BRUNSWICK STEAM ELECTRIC PLANT
TECHNICAL SUPPORT MEMORANDUM

TSM 91-0856
File No. 5095

SUBJECT: Long Term Operability of EDG #3

Attachment 1

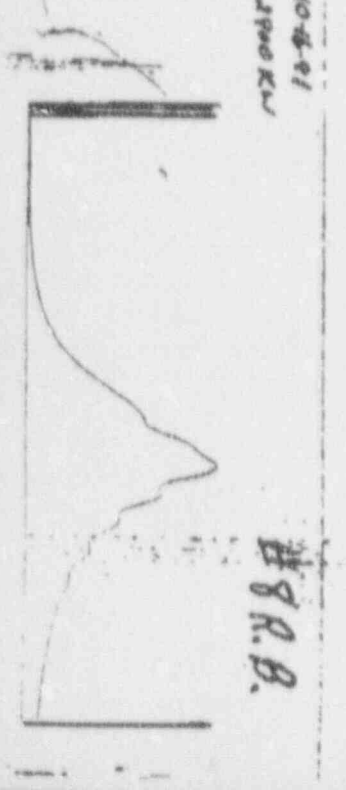
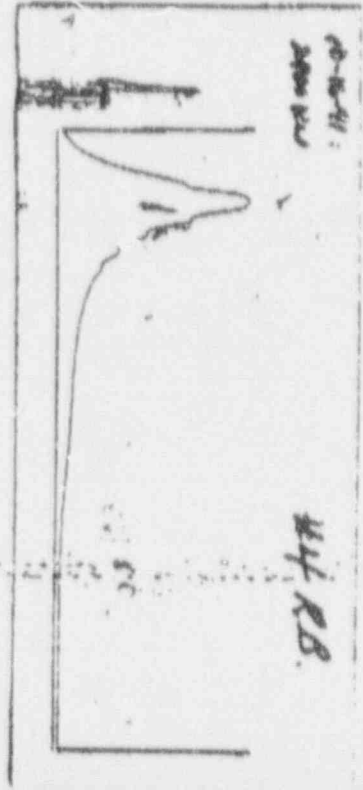
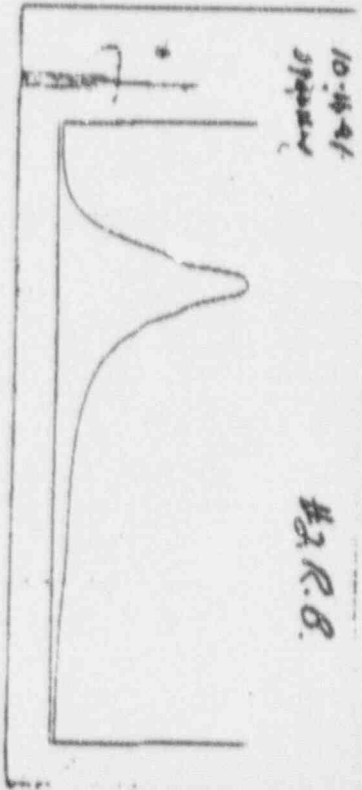
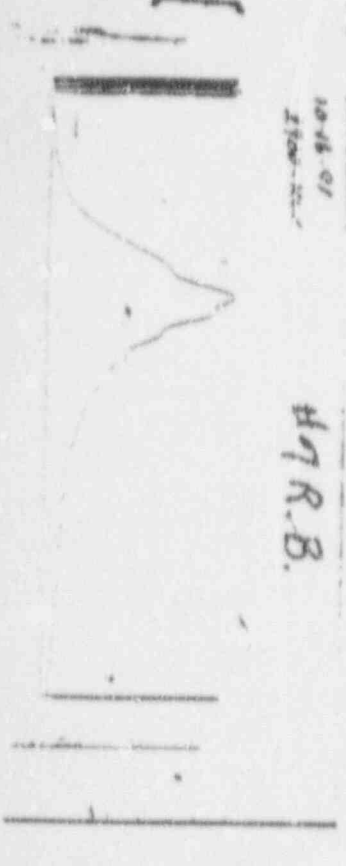
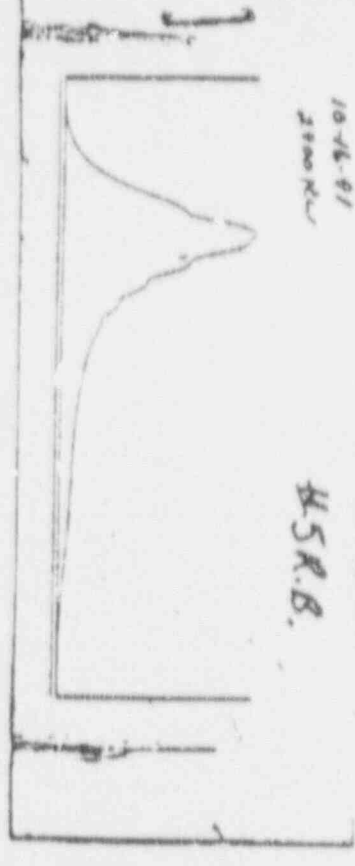
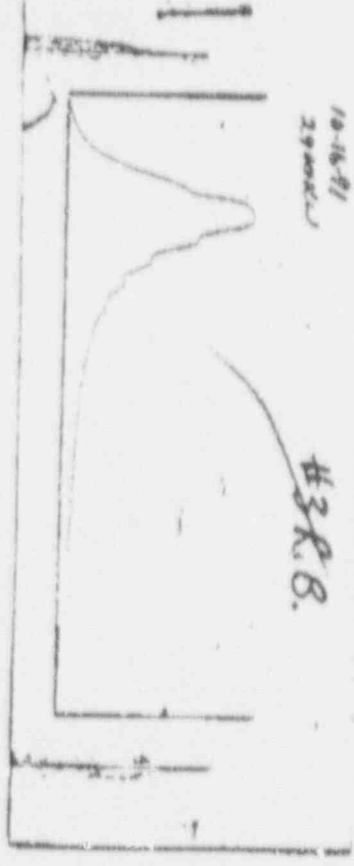
- 1) Did the high temperature damage the intake valves?
- 2) Was any of the EDG equipment damaged by the high temperature?
- 3) What parameters did the vender inspect during the run?
- 4) Is Tech Support satisfied with the current engine data?

1) No. The material of construction of intake and exhaust valves are identical except that the exhaust valves are stellite faced. Pull cards were taken on the PMTR run on 10/16/91. The pull cards measure both the compression and ignition pressures of the cylinders during actual running conditions. The compression pressures were approximately 775 psi and were within 40 psi of each other. These values were within the normal range and in close agreement with the last set of pull card readings. This indicates good cylinder compression, and therefore, no valve or valve seat damage. Additionally, besides no degradation of the valves, this analysis shows that the engine is performing well. (Reference Attachment 1)
